Circolare TecnicaService Bulletin - Technisches Rundschreiben - Circulaire Technique - Circular
Tecnica**555**

Date: **07/06/2001**Subject: **REPLACEMENT OF CLOSING ROCKER ARMS (part no. 209.1.013.1a -
209.1.014.1a)**Product: **996R****FUNCTION-RELATED RECALL CAMPAIGN**

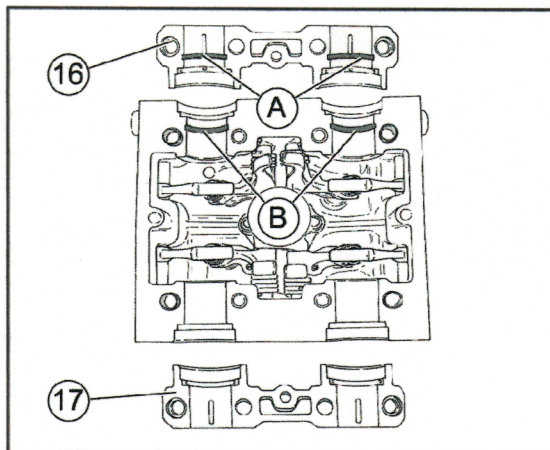
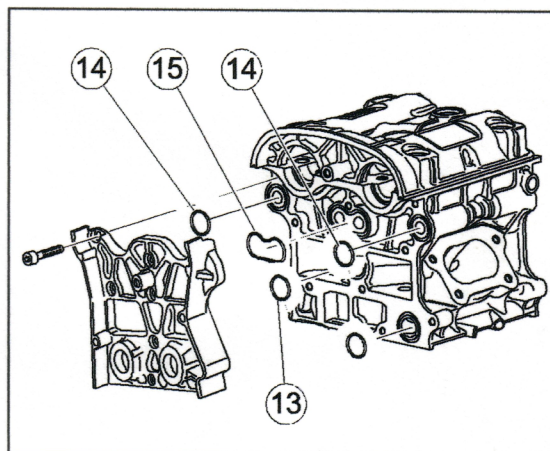
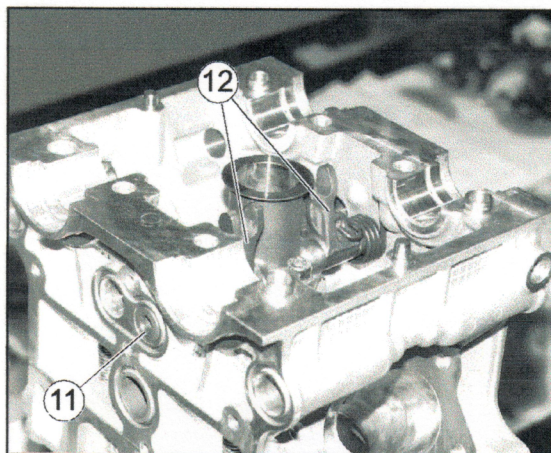
Replace the RH closing rocker part no. 209.1.013.1a with rocker part no. 209.1.013.3a and the LH closing rocker part no. 209.1.014.1a with rocker part no. 209.1.014.3a

(13) part no. 938.2.320.87

(14) part no. 463.2.050.5A

(15) part no. 788.1.064.1A
